## SUBDIVISION REVIEW SHEET

**CASE NO.:** C8J-2022-0351

**SUBDIVISION NAME:** Whisper Valley Multifamily- Parcel 3 & 4

**Exhibit C: Comment Report**  
**CITY OF AUSTIN – TRAVIS COUNTY – SINGLE SUBDIVISION OFFICE**  
**SUBDIVISION APPLICATION – MASTER COMMENT REPORT**

### Q TABLES FOR PROPOSED ROW (FETCHING AVENUE)

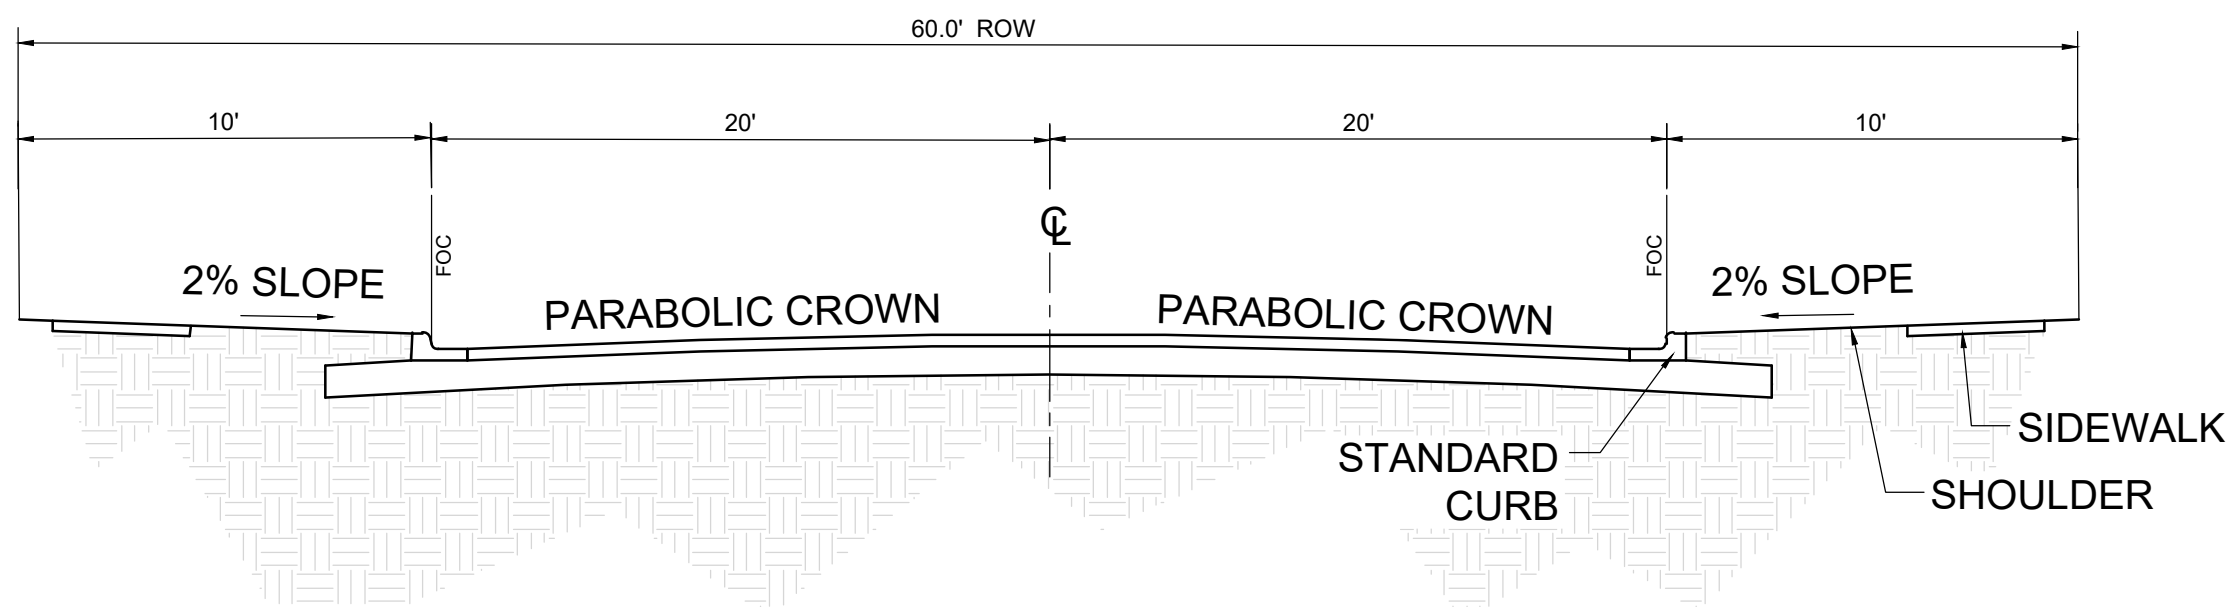
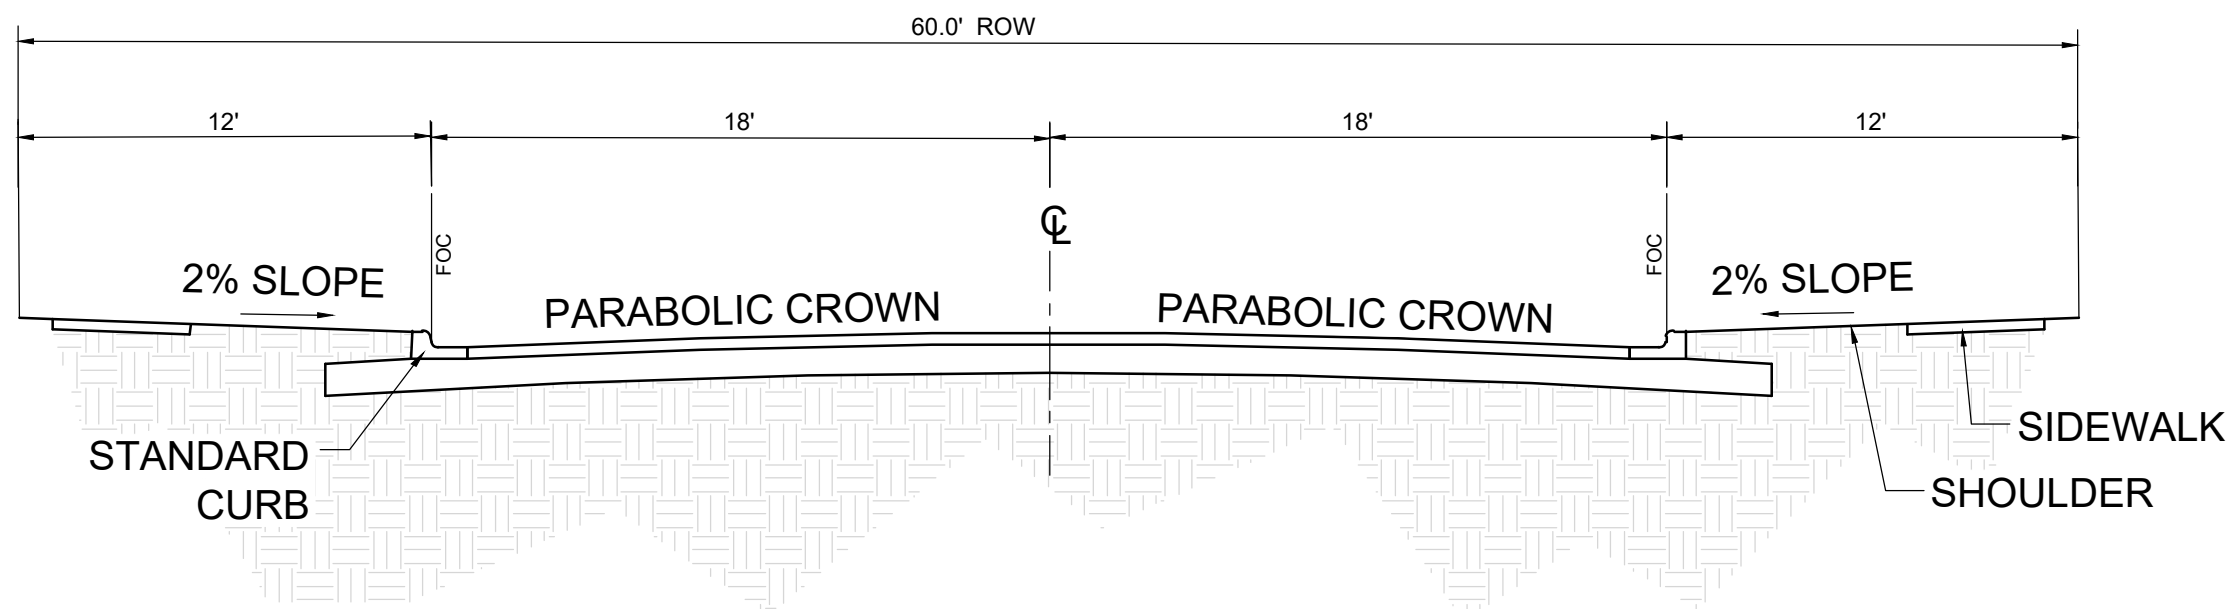
Please revise the street information table for Fetching Avenue to collector classification and adjust sidewalk widths to min. 5' on both sides.

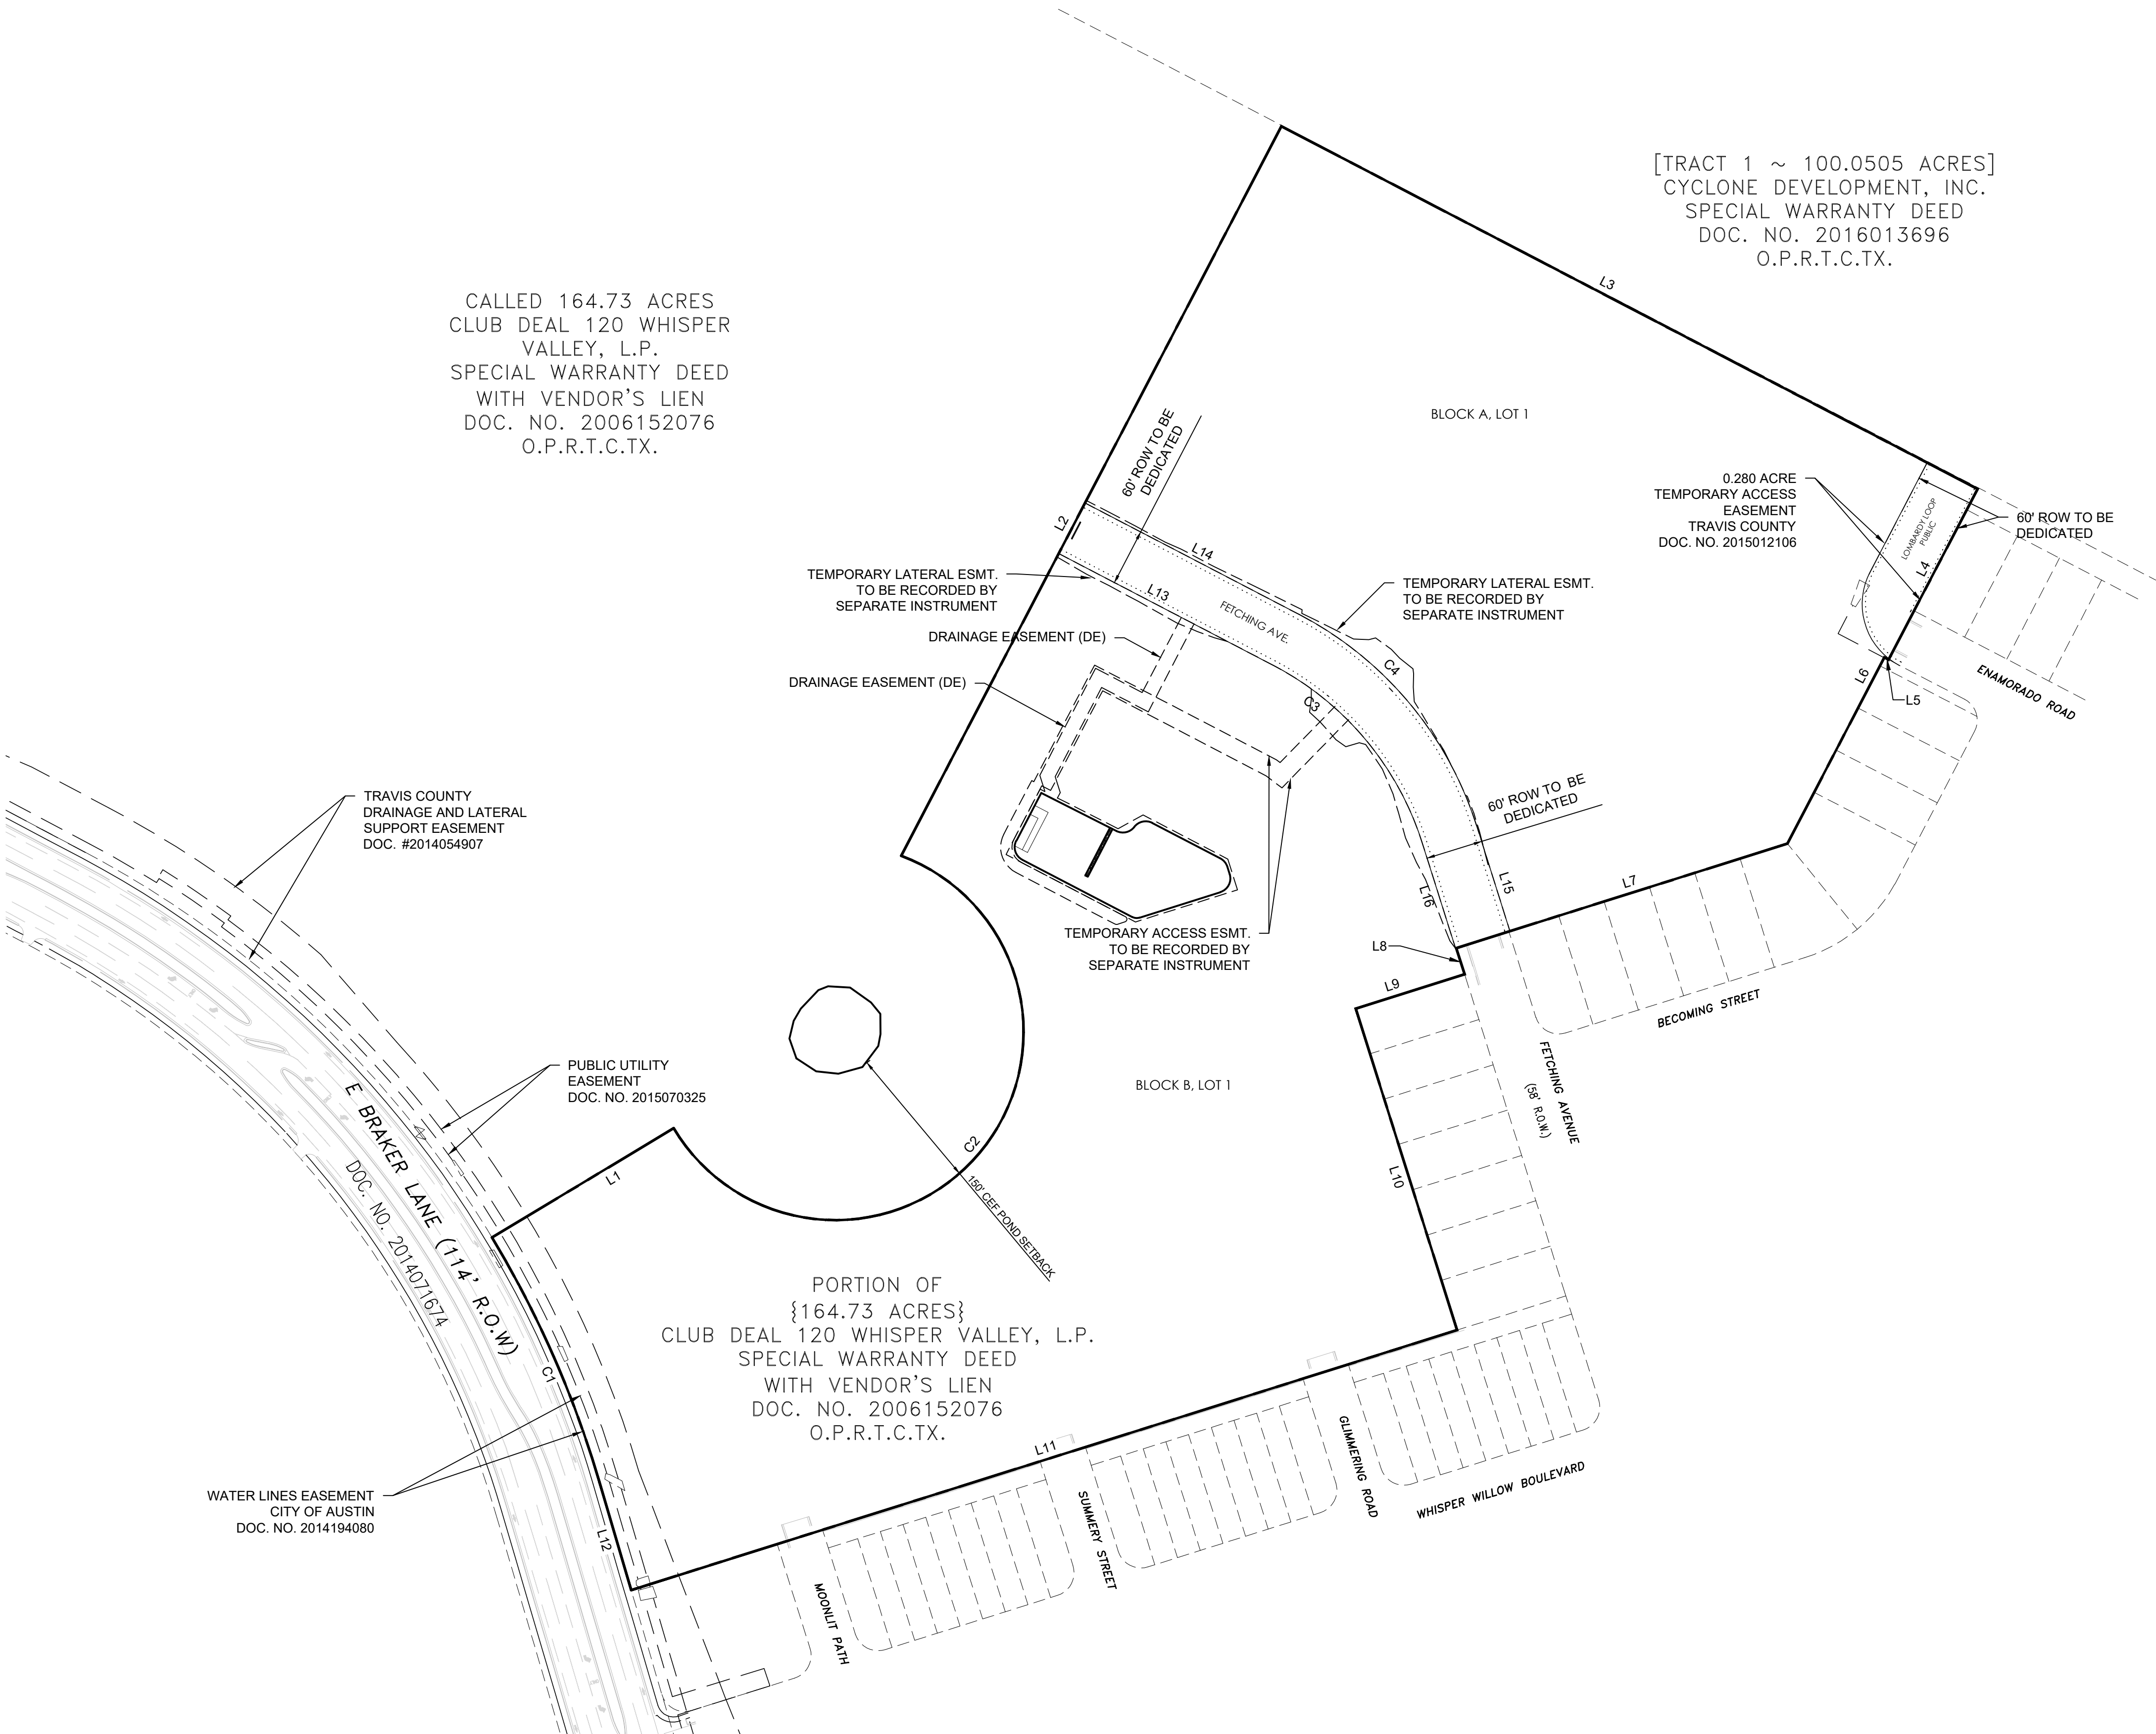
**TCSR7.** Provide a survey tie across Fetching and Lombardy to verify the ROW width. 30-1-113

**TCSR8.** Provide a turnaround easement for Fetching Lane. This will need to be in place until the extension to the northwest toward the proposed FM 973 realignment. Dead-end streets that are stubbed out for future extension to the adjacent property must terminate in an open-ended cul-de-sac if the dead-end street is more than 150 feet long. TCM, 1.3.2.E. Provide an open-ended cul-de-sac with a right-of-way radius at the end of Fetching Avenue. § 30-2-152

**TR 1.** Lombardi Loop is not shown in the proper configuration; please revise the right of way boundary configuration to correspond to an elbow street (See TCM Figure 1-25, August 7, 2020, TCM.)

**TR 2.** Provide a turnaround easement for a turnaround bubble at the western termination of the extension of Fetching Street.

**EXHIBIT A**

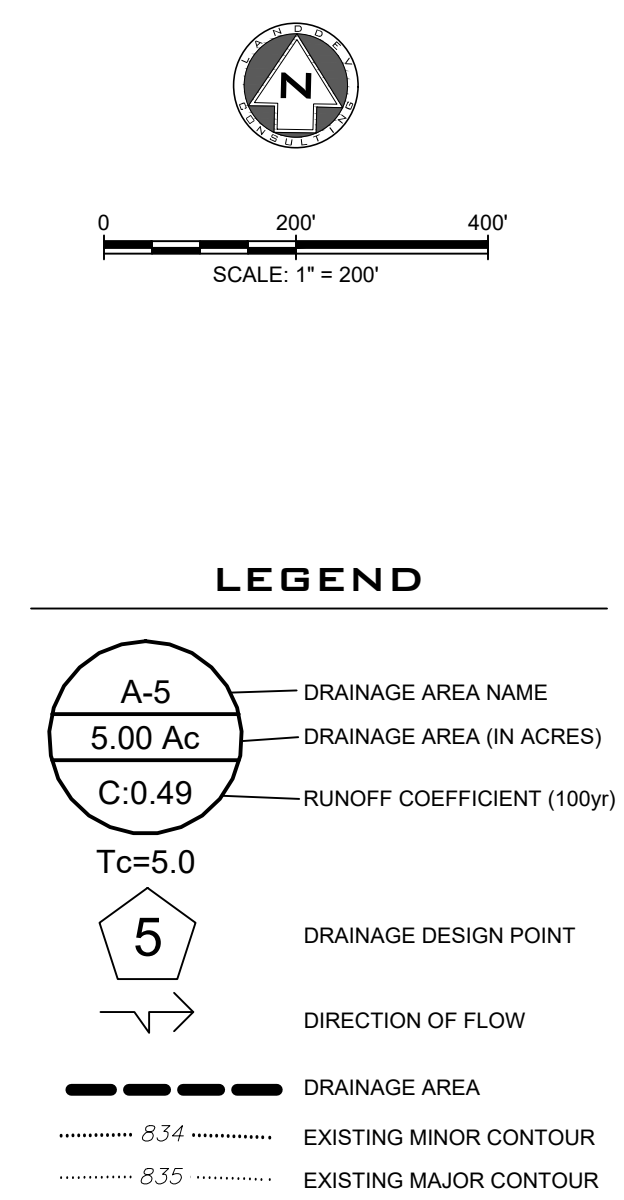
**DR 1.** Update the drainage analysis and drainage report for this development as needed to provide a comparison between predevelopment and post development stormwater peak flows that exit the subdivision boundary for the four design storm events as provided in the City of Austin Drainage Criteria Manual.
